Addendum No. 1 **March 23, 2023**

City Project No.: 22-001
Citywide Street Rehabilitation and Improvement Project Package 1

This addendum includes revisions to Plans and Specifications and provides clarifications and answers to questions submitted to the City.

DRAWING No. L-01
SHEET: 12 OF 169

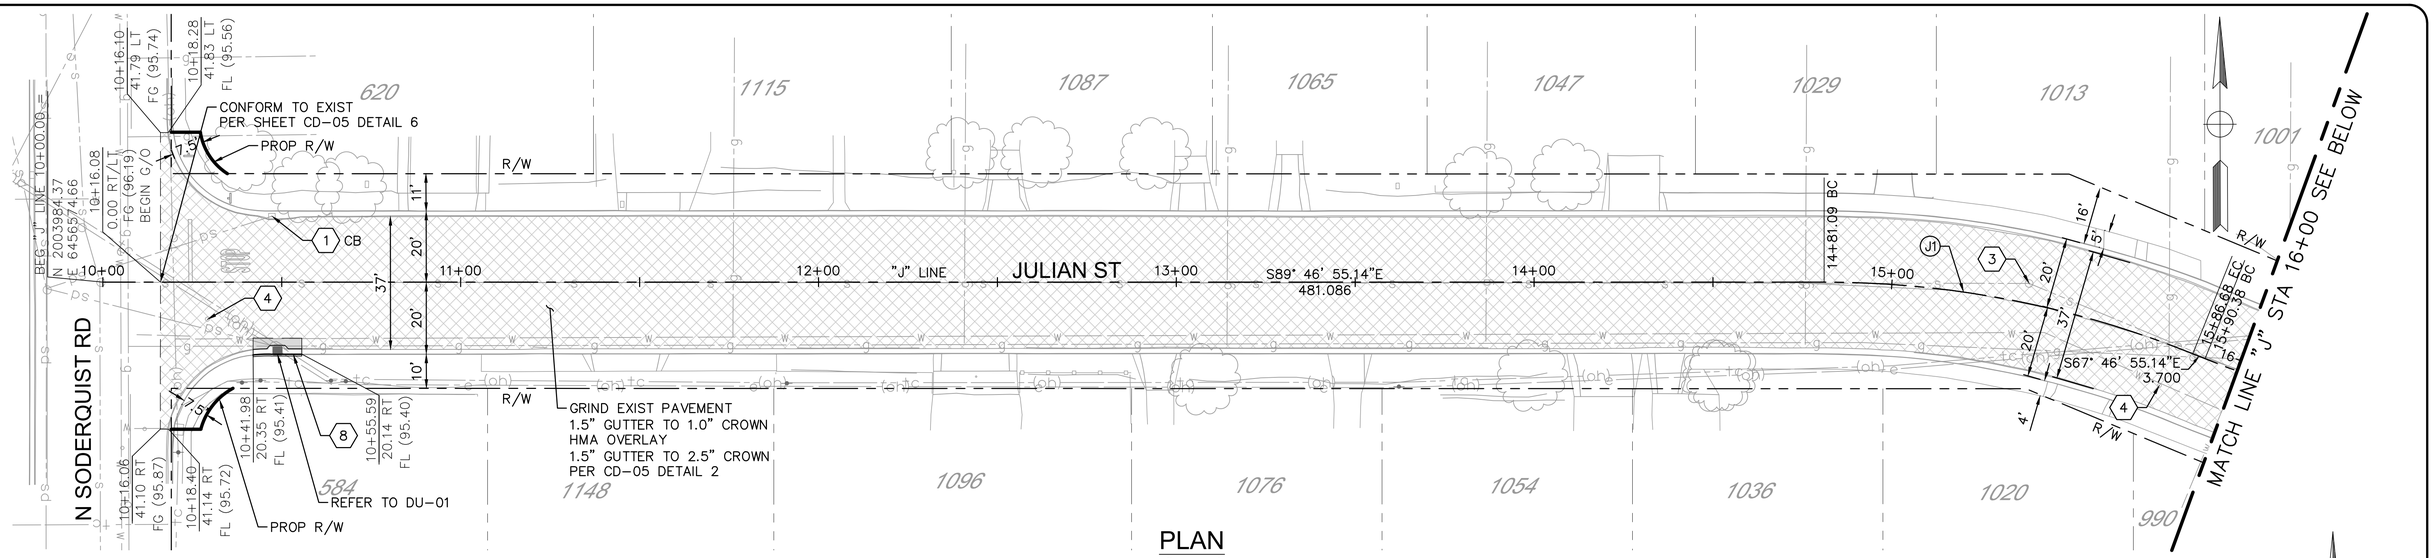
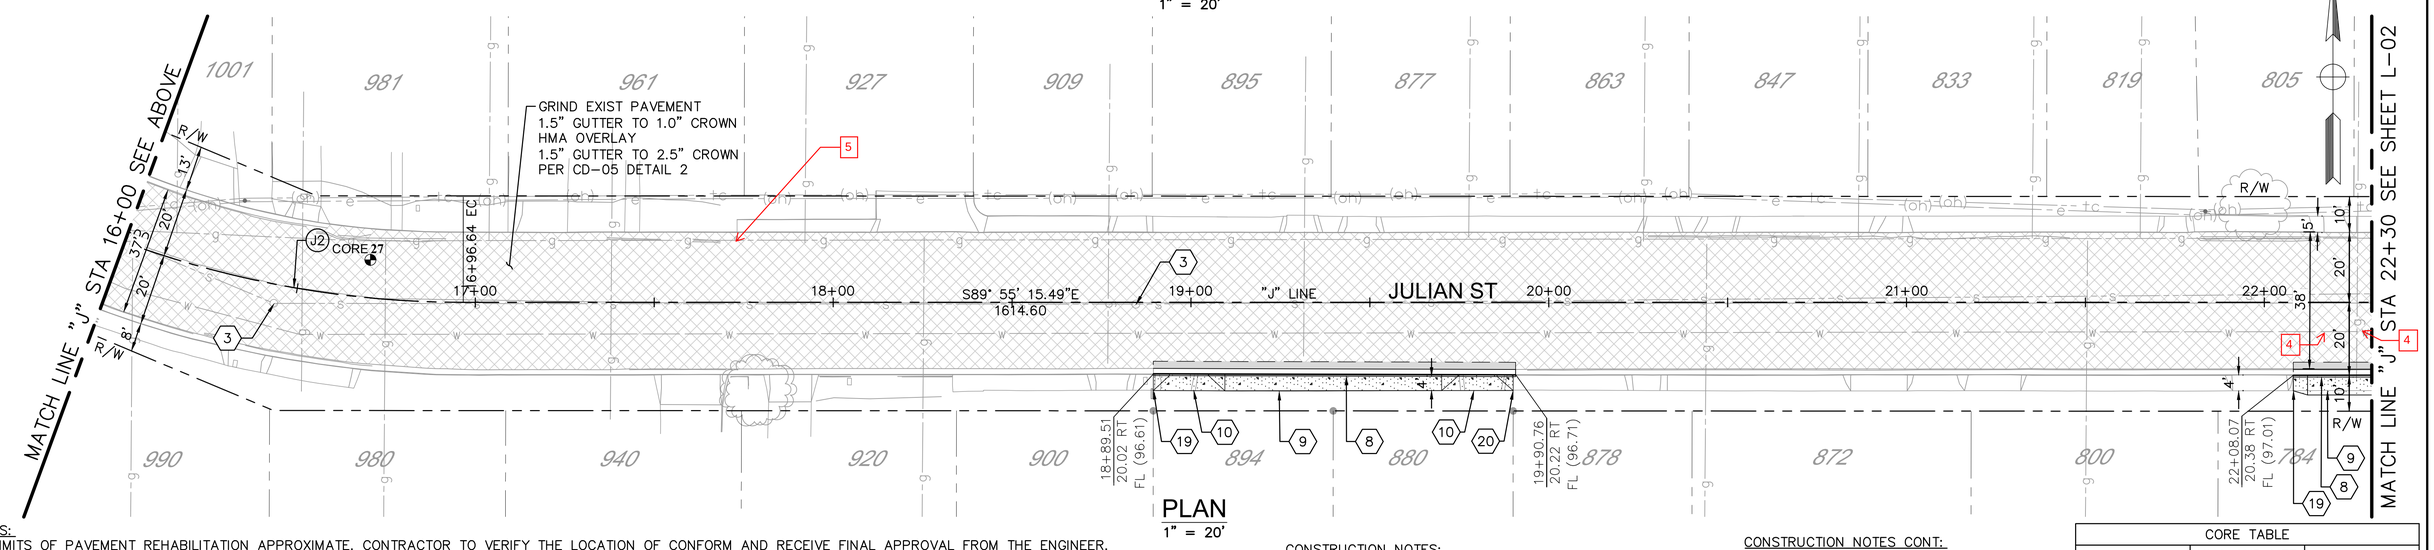
A2: Only the trees identified in the table below shall be removed. All others shall be protected in place. Bid Schedule quantity has been revised accordingly. Contractor's attention is directed to Note 14 on Drawing L-01.

Contractor's attention is directed to Note 10 on Drawing L-01 and Note 7 on Drawing TC-02.

DRAWING No. L-04
SHEET: 15 OF 169

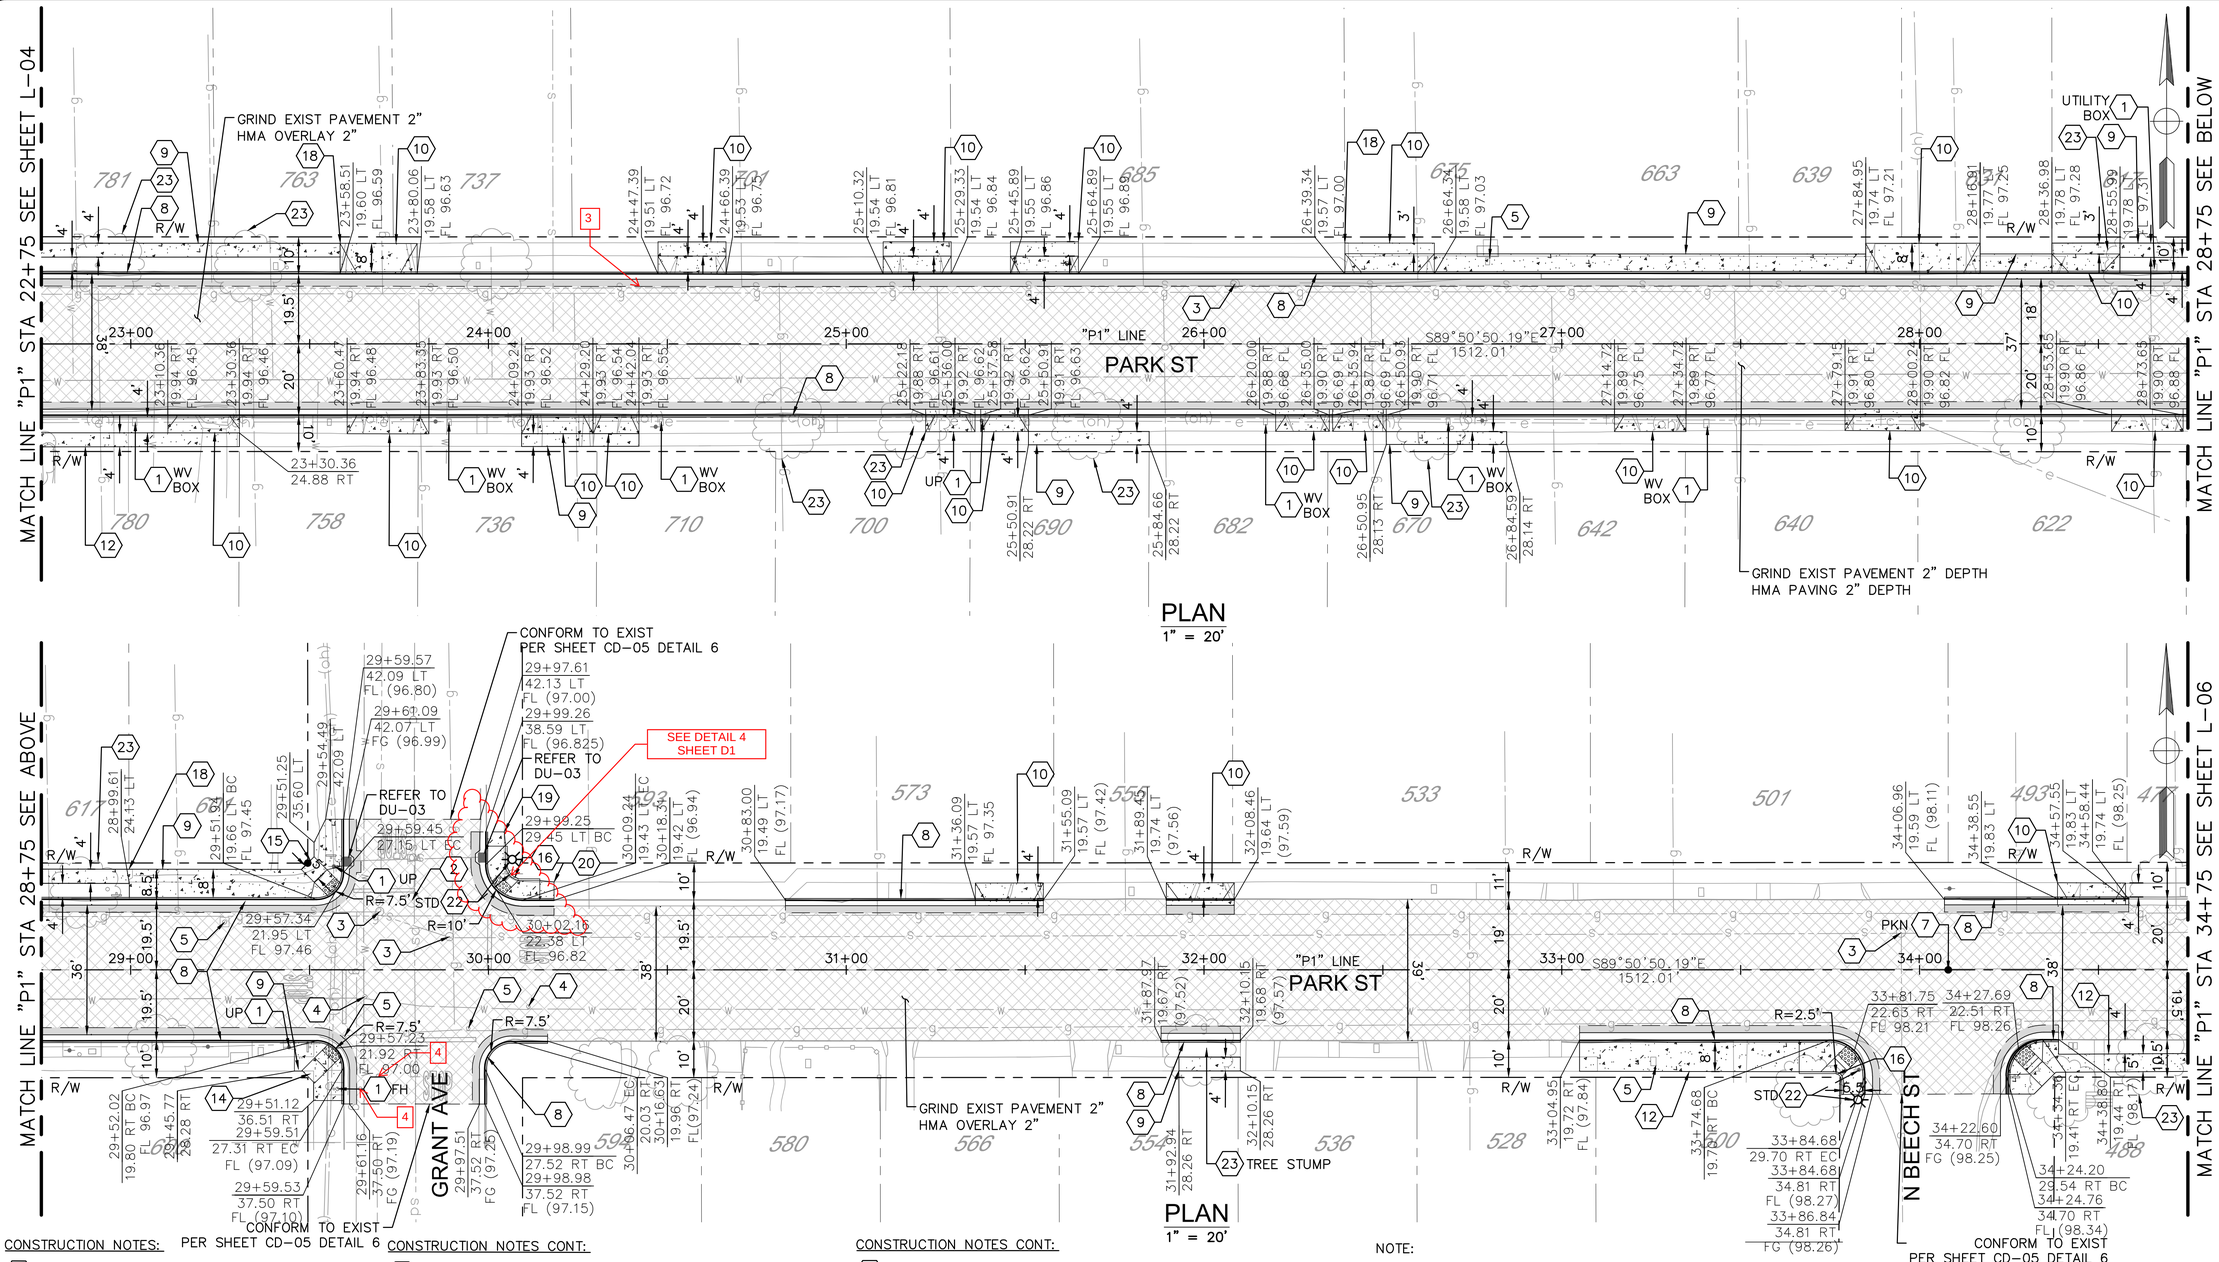
17. CONSTRUCT CURB RAMP PER STD C-14
18. MATCH EXIST EDGE OF SIDEWALK
19. BEG TRANSITION MATCH EXIST EDGE OF SIDEWALK
20. END TRANSITION MATCH EXIST EDGE OF SIDEWALK
21. REPLACE EXISTING STREETLIGHT IN PLACE (NOT IN CONTRACT)
22. RELOCATE AND REPLACE EXISTING STREETLIGHT ~~(NOT IN CONTRACT)~~
23. REMOVE TREE

DRAWING No. L-05
SHEET: 16 OF 169

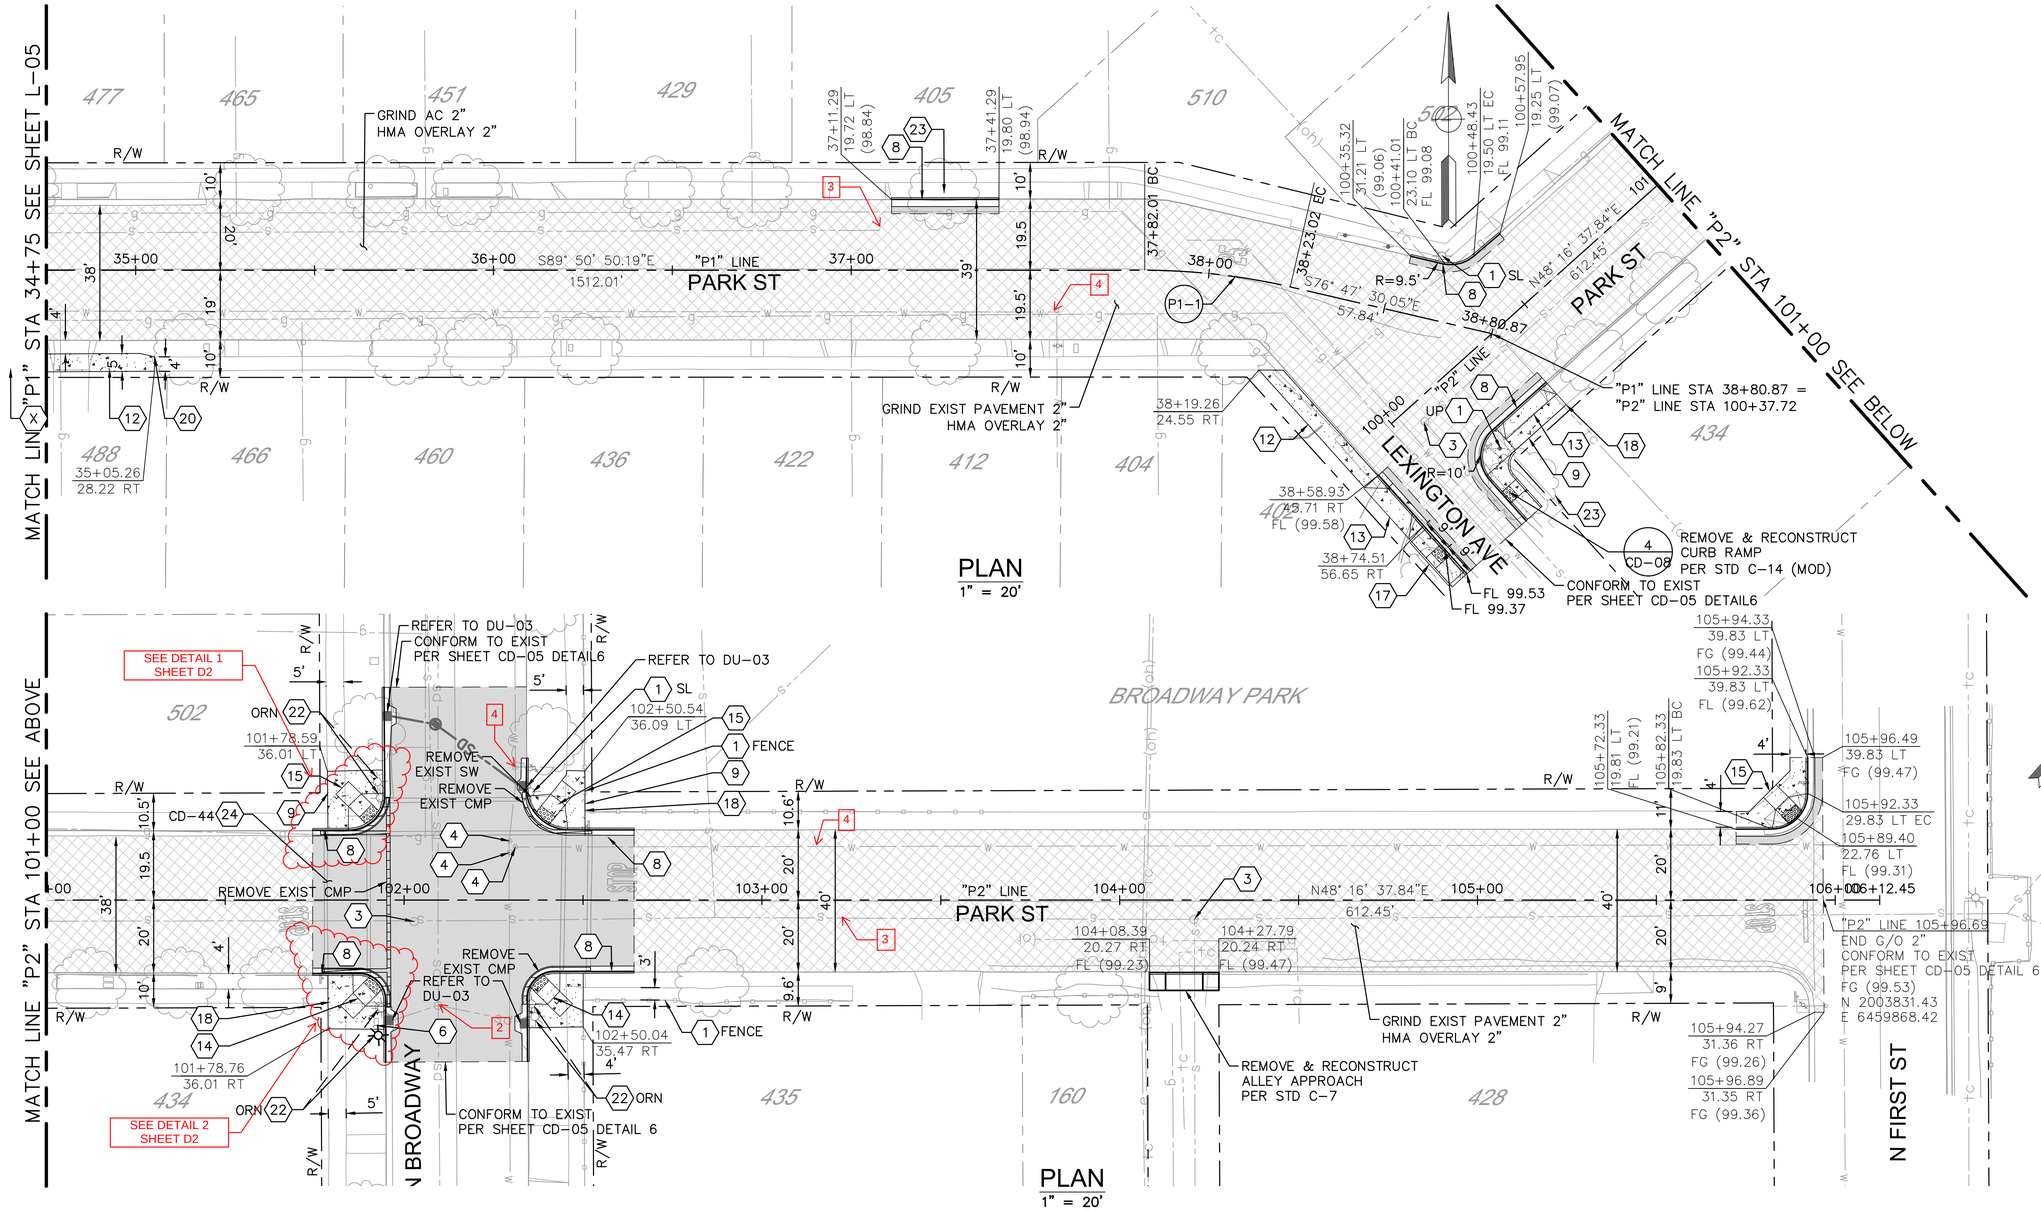
Location	Station	Drawing
Park Street		
617 Park Street	28+50L	L-05
617 Park Street	28+80L	L-05
434 N. Broadway (Intersection of Park St. & Lexington Ave.)	100+15R	L-06
Flower Street		
390 Flower Street (Intersection of Flower St. & N. Orange St.)	38+25R	L-09
390 Flower Street	38+45R	L-09
374 Flower Street	38+75R	L-09
338 N. Broadway (Intersection of Flower St. & Lexington Ave.)	41+20R	L-09
338 N. Broadway (Intersection of Flower St. & Lexington Ave.)	41+30R	L-09
338 N. Broadway (Intersection of Flower St. & N. Broadway)	42+75R	L-09
N. Orange Street		
403 W. Main Street (Two small trees behind sidewalk)	10+50	L-12
403 W. Main Street	11+25L	L-12
123 N. Orange Street	12+25L	L-12
Locust Street		
318 Locust Street	17+10R	L-13
318 Locust Street	17+25R	L-13
